61 Right - 1 - The Sedona 5 (30-5C) Elev A
CEILINGS

Sedona 5
Elev A
Lot 61 R

Second Floor
Elevation A

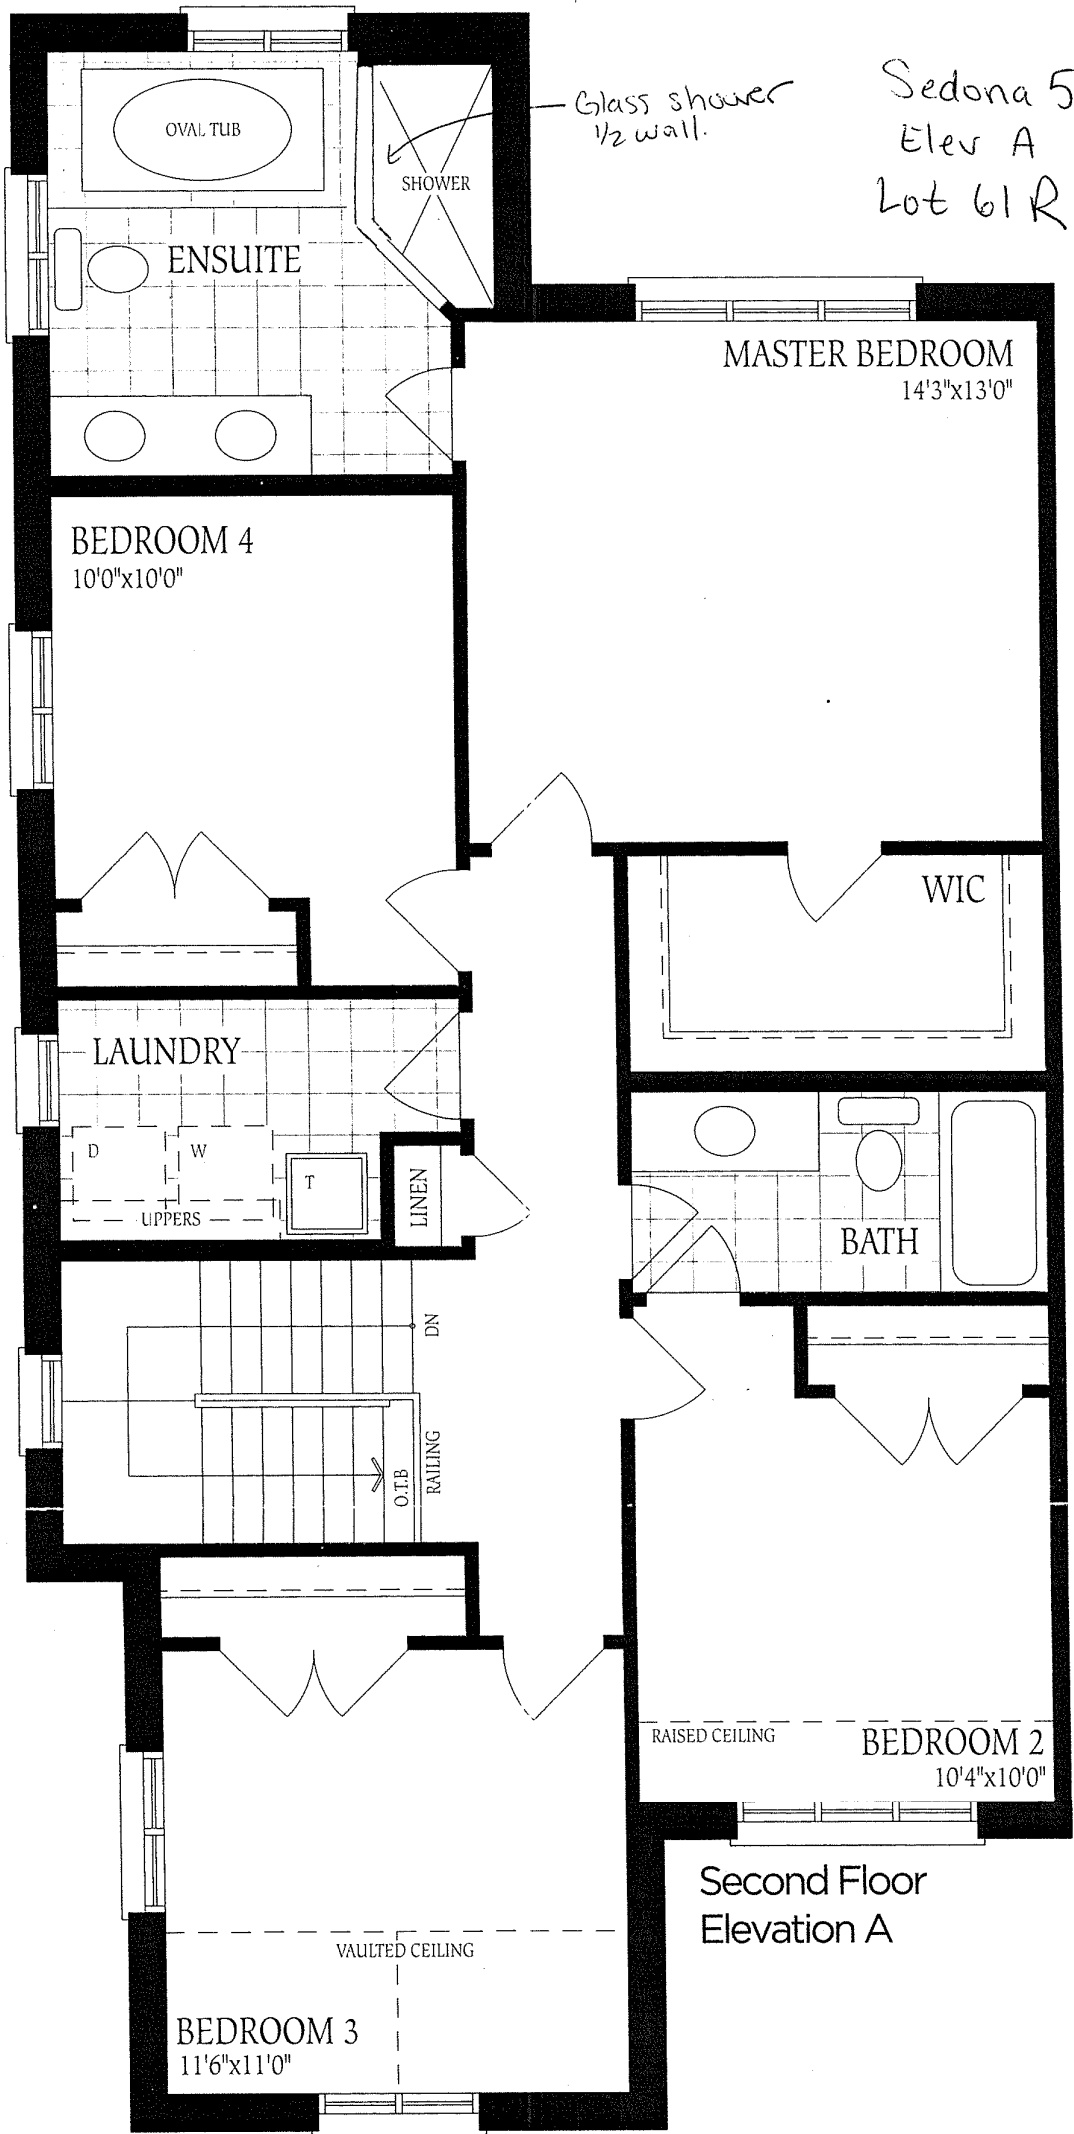
Inv.170	1 - HARDWOOD - STANDARD - 2¼ MERCIER SOLID OAK - STANDARD COLOURS - UPPER HALL
Line1705	Note:
12Jul15 / 3Sep15	
Inv.170	1 - HARDWOOD - STANDARD - 2¼ MERCIER SOLID OAK - STANDARD COLOURS - LANDING
Line1709	Note:
12Jul15 / 3Sep15

Inv.170	1 - FRAMELESS GLASS SHOWER ENCLOSURE FOR TOWNS & SEMI FOOT S PLAN PENDING -MASTER ENSUITE - 1/2 WALL (APPROX 1 FOOT HIGH) BETWEEN TUB AND SHOWER WITH GLASS TOP
Line1706	Note:
12Jul15 / 3Sep15

Inv.170	1 - UPGRADE RAILING - UPGRADE 2 - LEVEL 1 - WROUGHT IRON- BLACK
Line1707	Note:
12Jul15 / 3Sep15
